Dolby Laboratories Inc

Field Bulletin 218

Reverse Scan Analog Soundhead Readers Extending LED Life Solar cell preamp gain change and LED drive current change

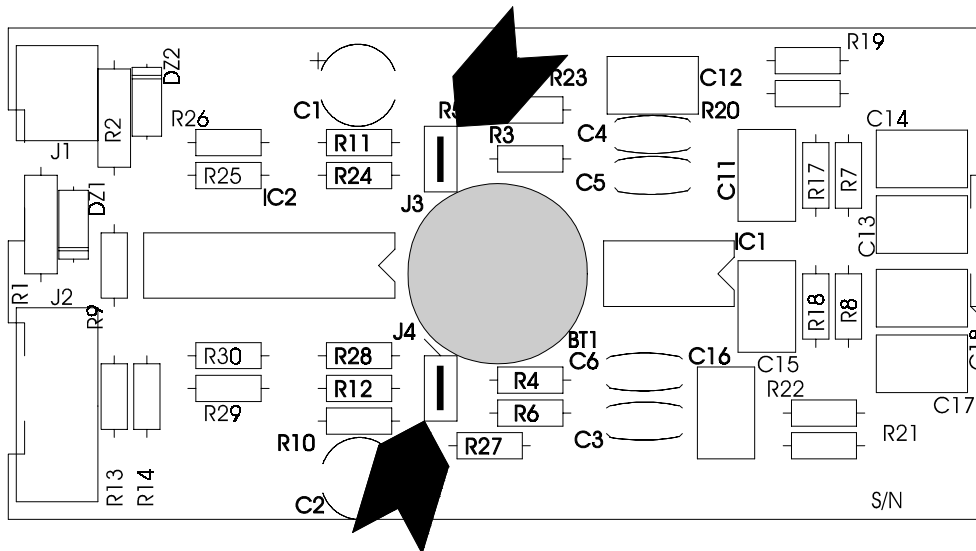
1. Use wire cutters to carefully remove jumper wires J3 and J4 on the Cat. No. 655 solar cell board. See the figure below showing jumper locations.

- Remove wire jumpers J3 and J4 on the Cat. No. 655 solar cell preamp board.
- Reduce the power supply current driving the LED while maintaining enough LED illumination to achieve Dolby Level.
